REMARKS

ANNOTATED SHEET SHOWING CHANGES

FIGURE 1

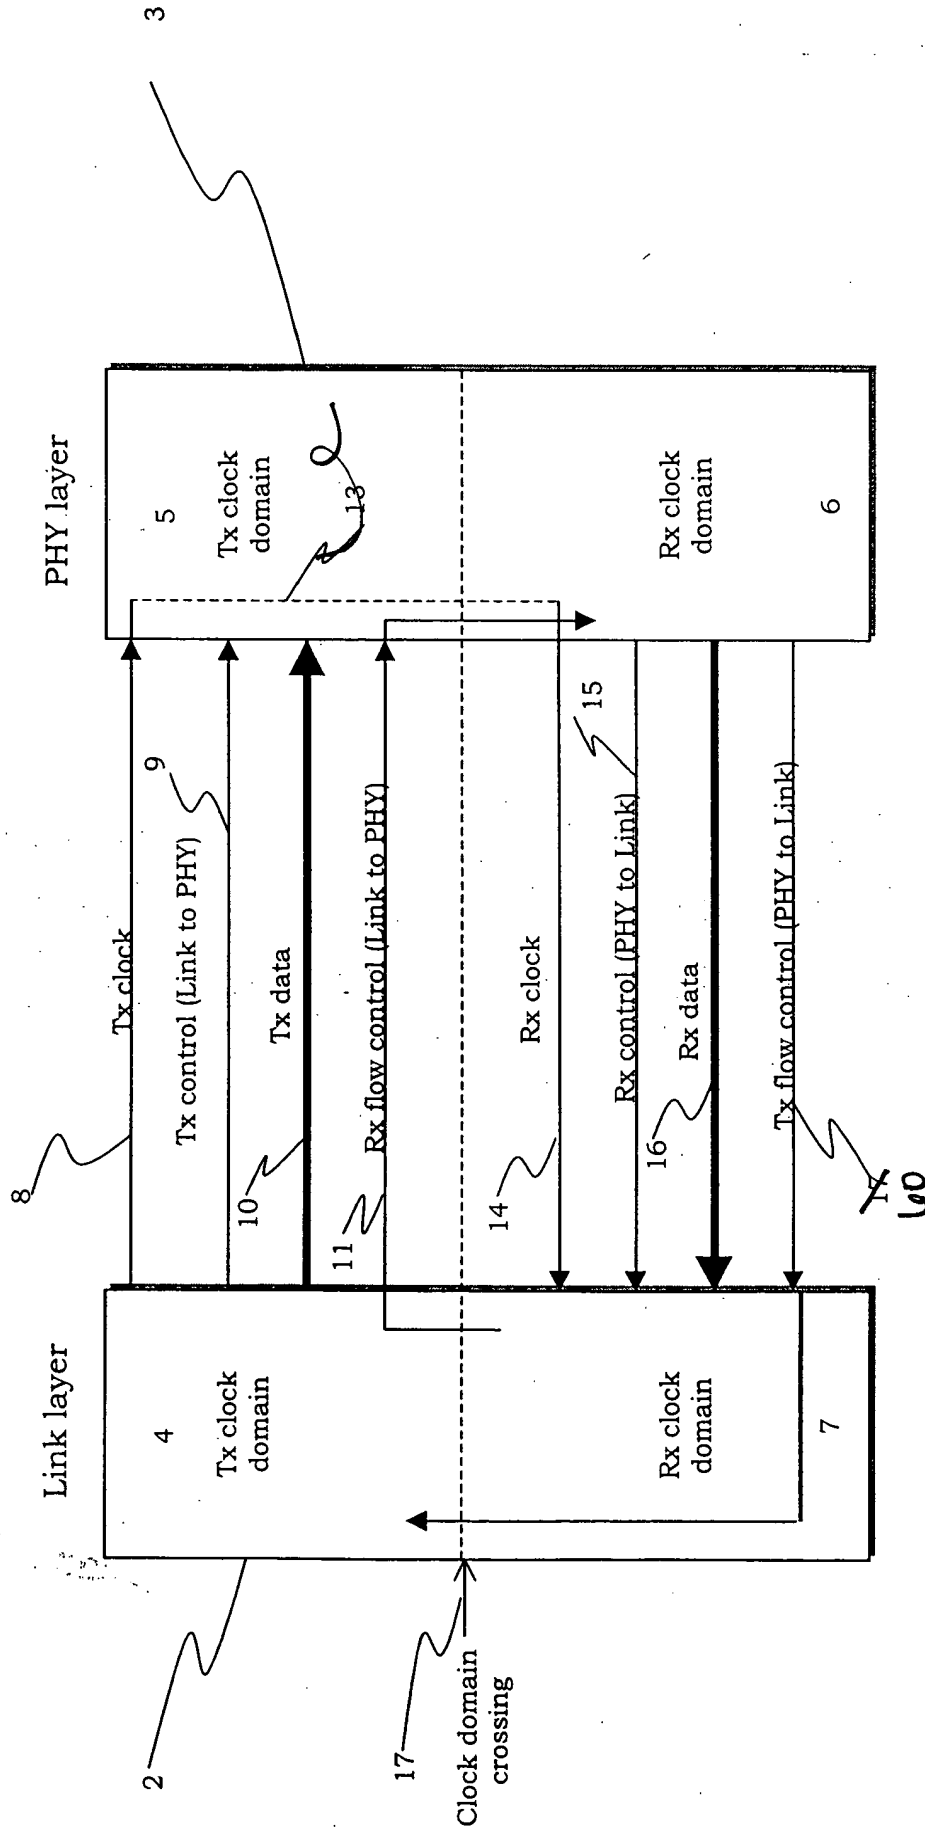
FIGs. 1 and 2 have been amended to delete reference numerals 12 and 13 respectively. Additionally, FIG. 1 has been amended to replace reference numeral 17, used to describe the TX flow control signal, with reference numeral 60. The detailed description has been amended to reflect the use of reference numeral 60.
